Re: McBane Conservation Subdivision Environmental Impact Assessment - **ADDENDUM**
Pittsboro, Chatham County
WR Project #02060411.02

RE: Review Comments – Environmental Impact Assessment for the proposed McBane Conservation Subdivision
JMT Job No. #19-03787-005

MIXED MOISTURE HARDPAN FOREST (G2) AND UPLAND POOL (G1) RECOMMENDED FOR CONSERVATION BY NCNHP

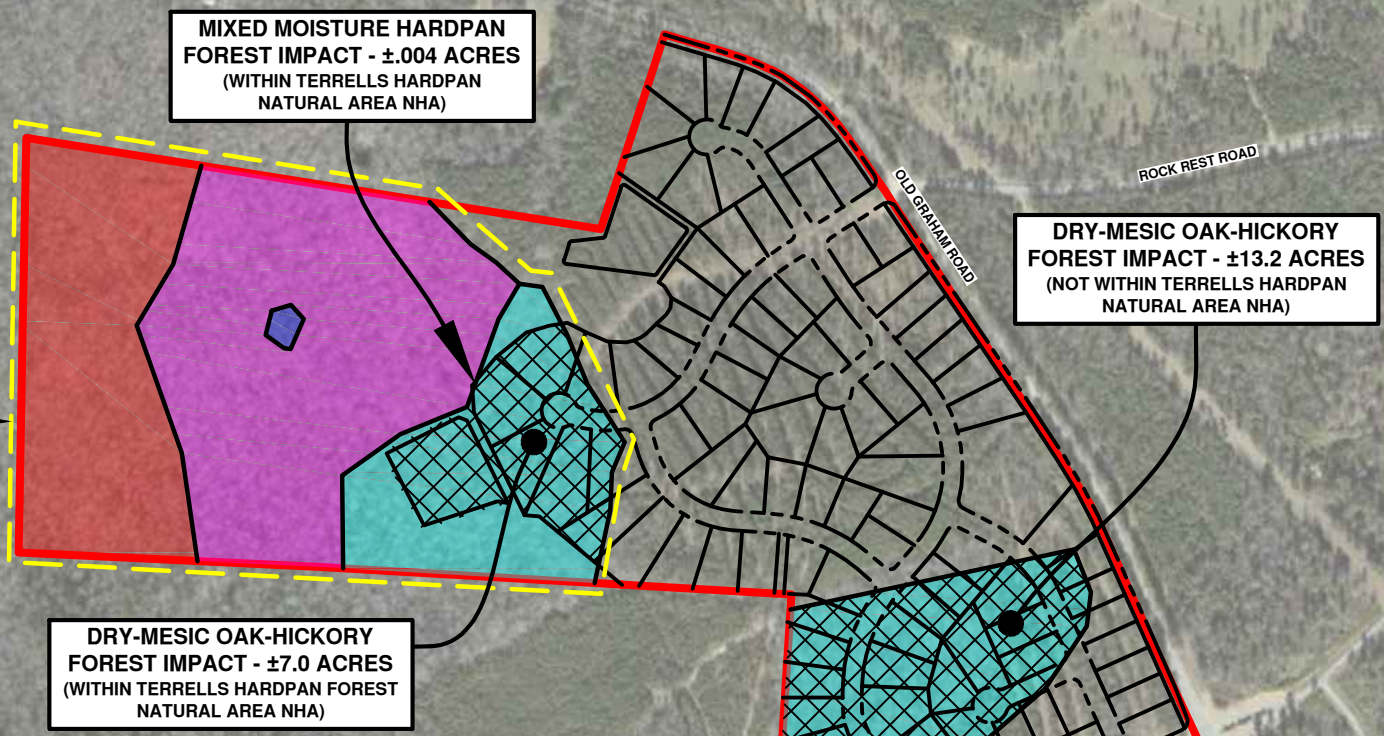
- *Comment: The Natural Heritage Area (NHA) in the northwest portion of the site appears to be impacted by lots and an SCM, but no discussion was provided.*

Reviewer Comment: Included. The area designated as Voluntary Open Space (3.70 acres) on Exhibit 5 appears to be located within the NHA. Explain why this is being used for open space rather than natural space. The SCM in that location appears to be located within the NHA. Can this be located outside the NHA. Lots 25-35 also appear to be in NHA. Acreage of impact to the NHA is not provided.

There are no proposed impacts to the Dry Oak-Hickory Forest (Piedmont Subtype)-G4G5 (EOID 39731.00) and Upland Pool (Typic Piedmont Subtype)-G1 (EOID 39728.00) within the northern conservation area. Additionally, there are no proposed impacts to the Piedmont Alluvial Forest-G4 in the southern conservation area which is not within the Terrells Hardpan Natural Area NHA and was not recommended for conservation by the NCNHP.

The proposed project will impact ± 0.004 acres of the Mixed Moisture Hardpan Forest (Piedmont Subtype)-G2 (EOID 39729.00) within the Terrells Hardpan Natural Area NHA, resulting in the conservation of 21.9 acres of this area.

The project will impact ± 7.0 acres of the Dry-Mesic Oak-Hickory Forest-G2 (EOID 39730.00) within the Terrells Hardpan Natural Area NHA, resulting in the conservation of 11.5 acres of this community. The project will also impact ± 13.2 acres of Dry-Mesic Oak-Hickory Forest-G2 within the central portion of the site which is not within the Terrells Hardpan Natural Area NHA and was not recommended for conservation by the NCNHP.

The proposed impacts within the Terrells Hardpan Natural Area NHA and other NCNHP classified natural areas are depicted in the attached On-Site Inventory Map (Map #5 of 6).

SCM #1 is located outside the mixed moisture hardpan area recommended for preservation by NCNHP. The Voluntary Open Space is shown as requested by the Chatham County Planning Department, to show additional area dedicated by the developer in addition to the requirements of the Conservation Subdivision Guidelines.

The proposed project will impact ± 0.004 acres of the Mixed Moisture Hardpan Forest (Piedmont Subtype)-G2 (EOID 39729.00) within the Terrells Hardpan Natural Area NHA, resulting in the conservation of ± 21.9 acres of this area as depicted in the On-Site Inventory Map (Map #4 of 6).
